## Addendum #1 - Pre-bid Meeting

### ATTHS - Nederland C.O. - Chiller Replacement - Reno Project #170896

AT&T–Nederland C.O  
Replacement of Chiller

## **ADDENDUM #1 (10/09/2017)**

SHEET TITLE: PARTIAL ROOF PLAN  
MECHANICAL RENOVATION PLAN

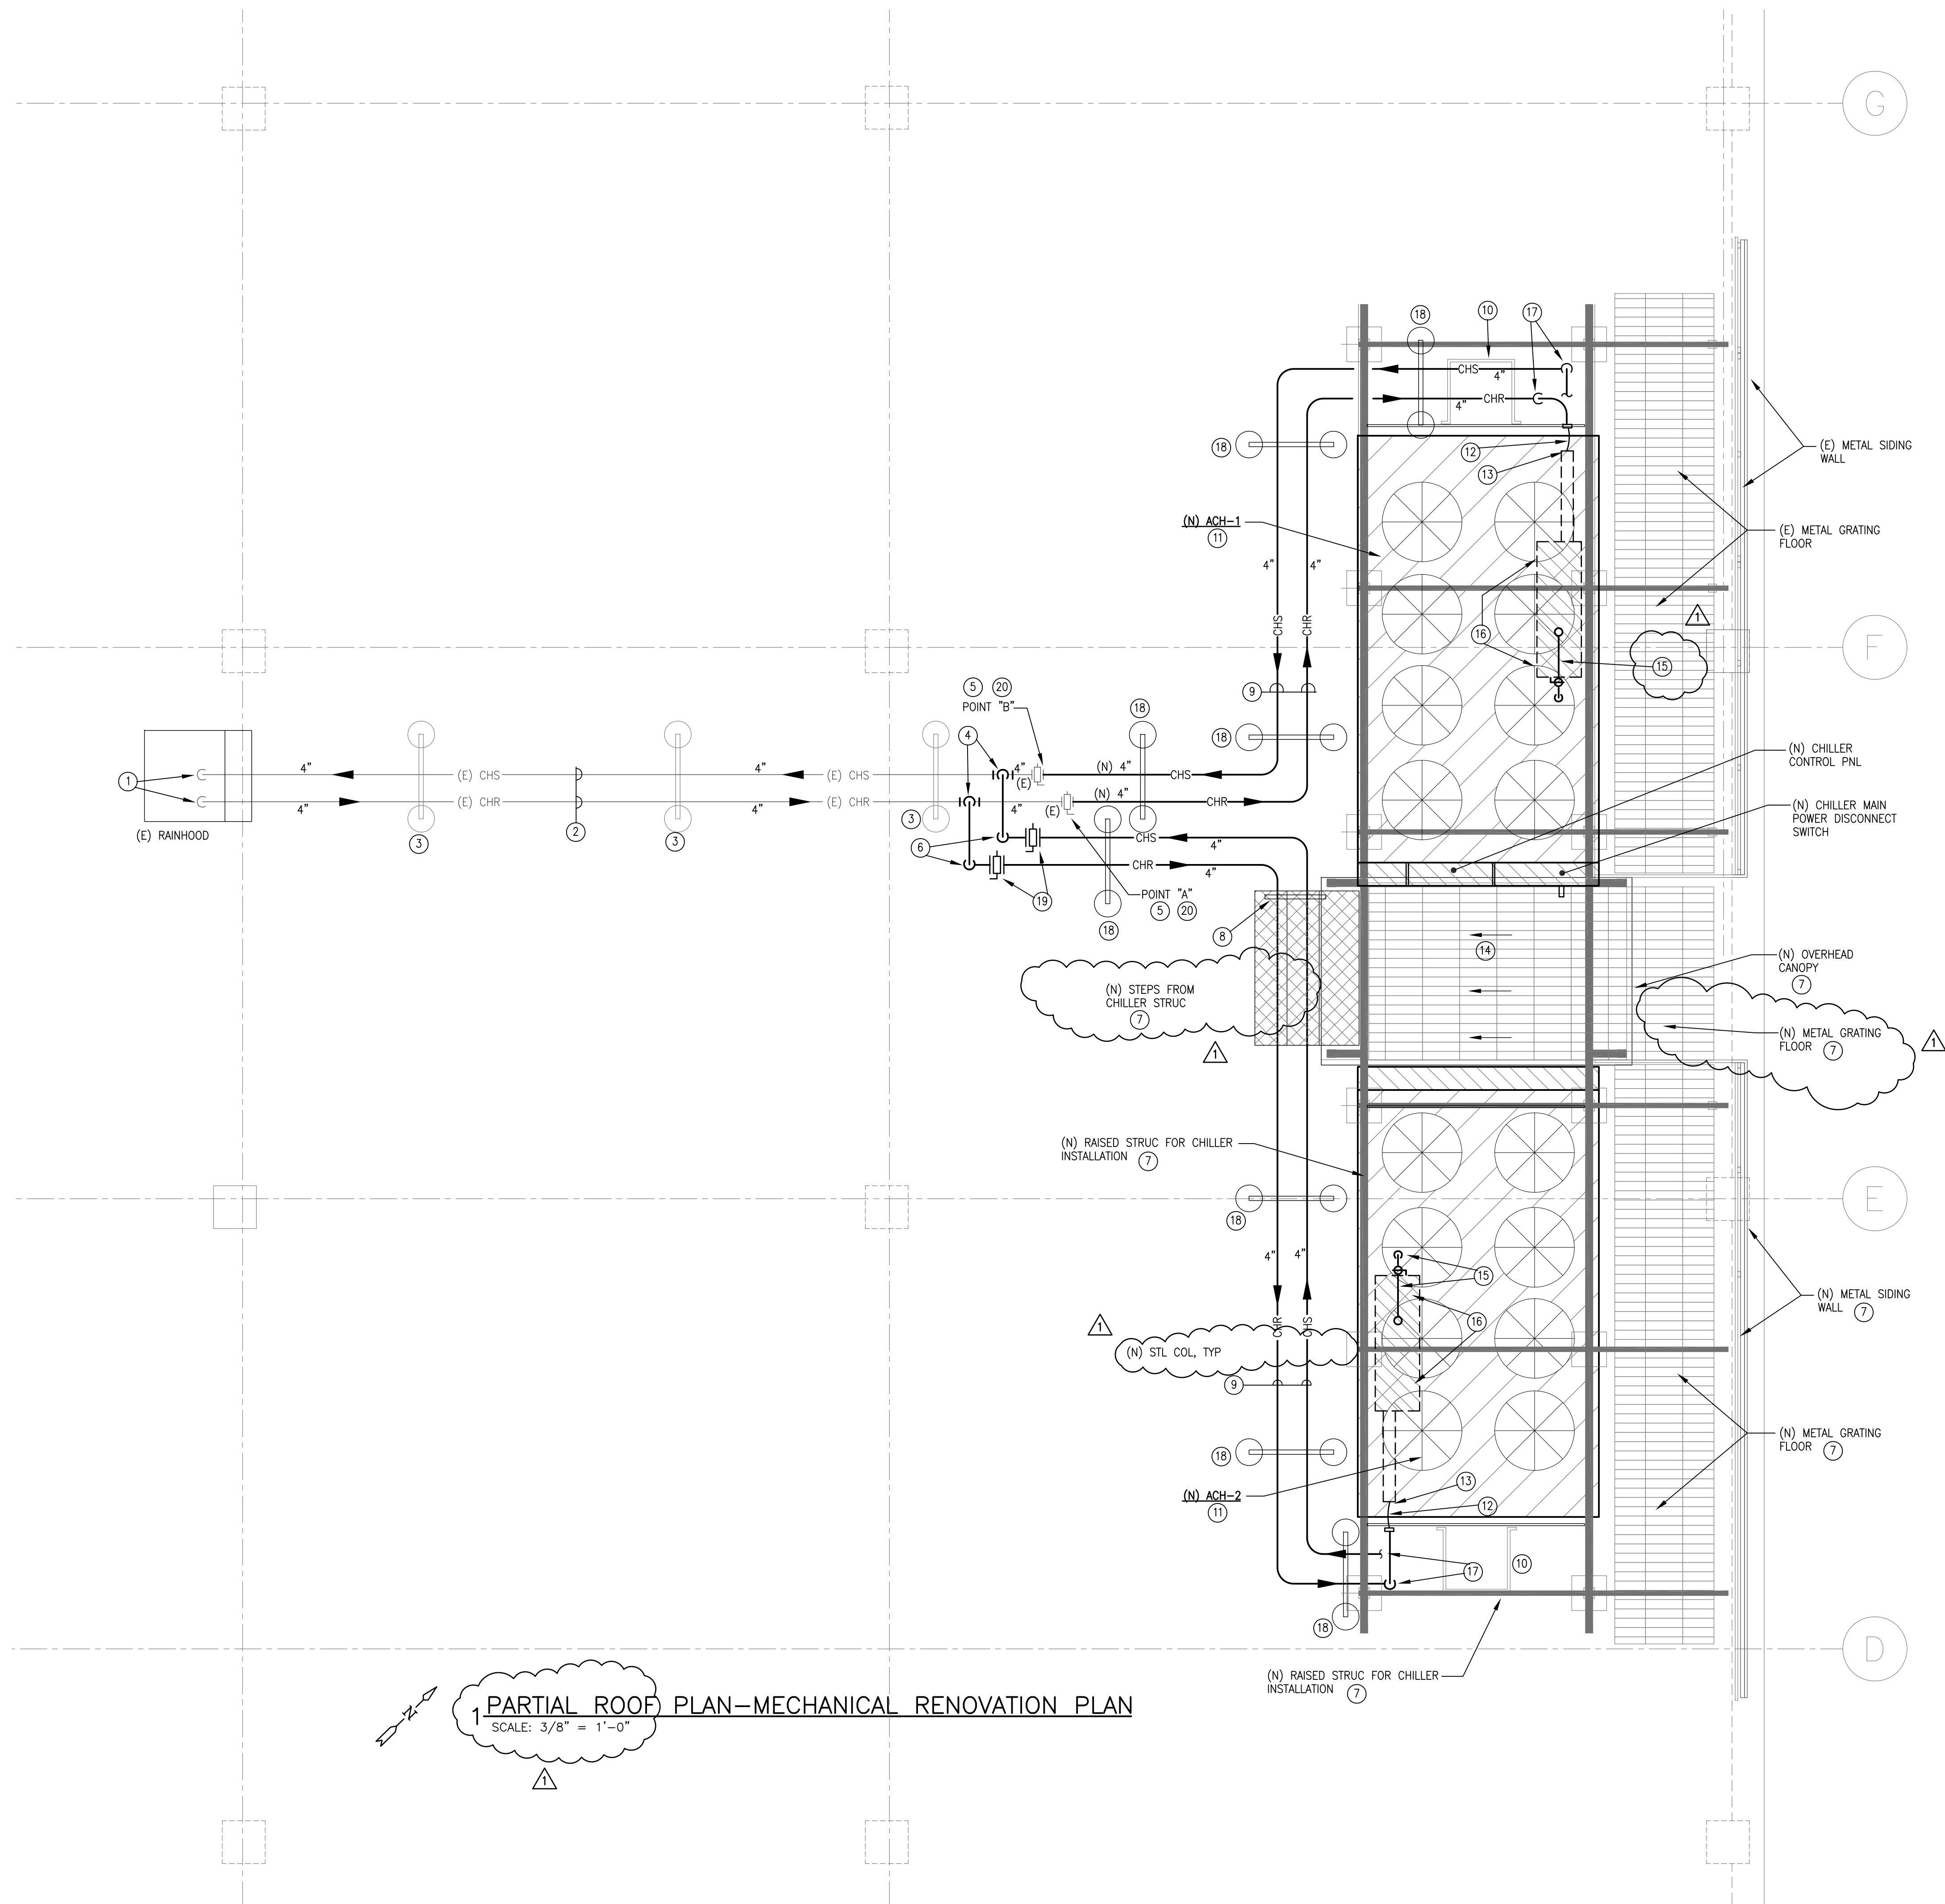
3. DWG. M1.06:
  - A. Approx 30 ft long existing 1" dia PVC CW line located on the pipe rack on the roof shall be removed and replaced with new 1" Sch. 80 PVC CW line with fitting. New line shall be connected to the existing line at the rain hood, supported from the rack and insulated using 1" thick Aramflex insulation.

- B. See revised DWG. M1.06 for missing notes.

SHEET TITLE  
PARTIAL ROOF PLAN  
ELECTRICAL RENOVATION PLAN

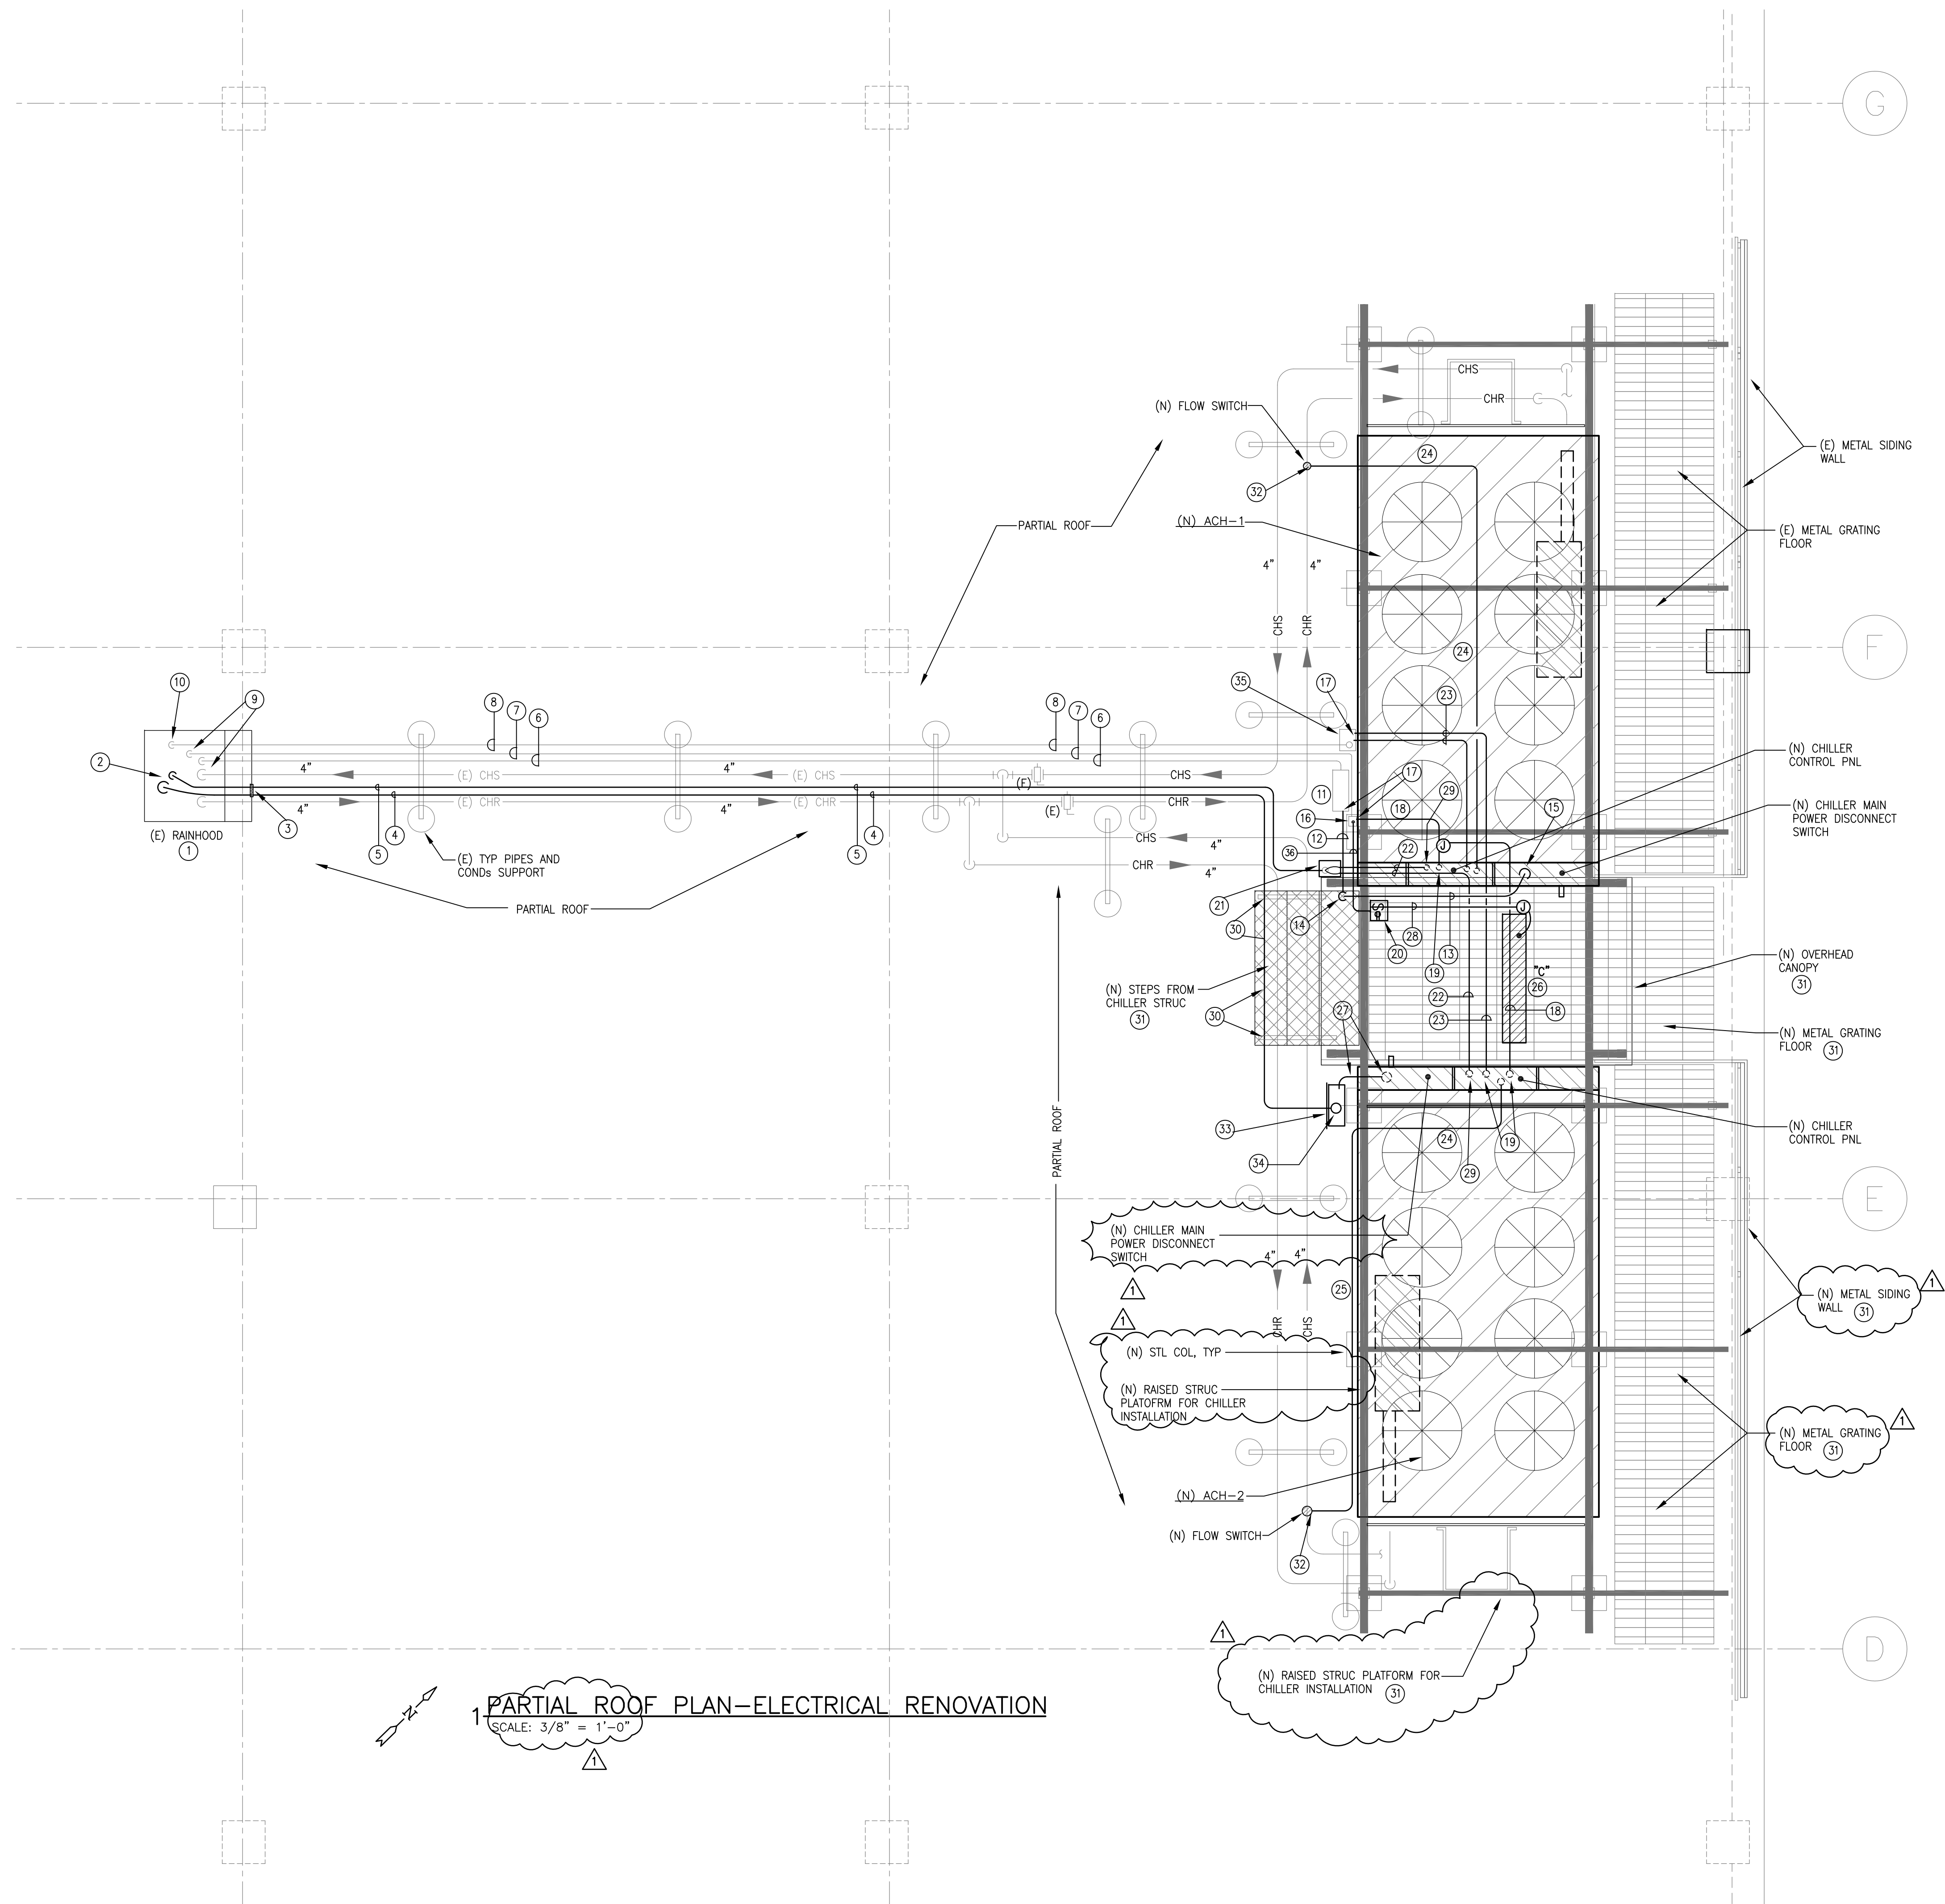
5. DWG. E1.03:
  - A. See revised DWG. E1.03 for missing notes.

- B. The existing outdoor light fixture installed on Canopy roof shall be removed, cleaned, reinstalled and rewired to new lighting branch circuit. A new similar light fixture shall also be furnished and installed on the canopy roof to shine over new ACH-2. It shall be connected to new lighting branch ckt.
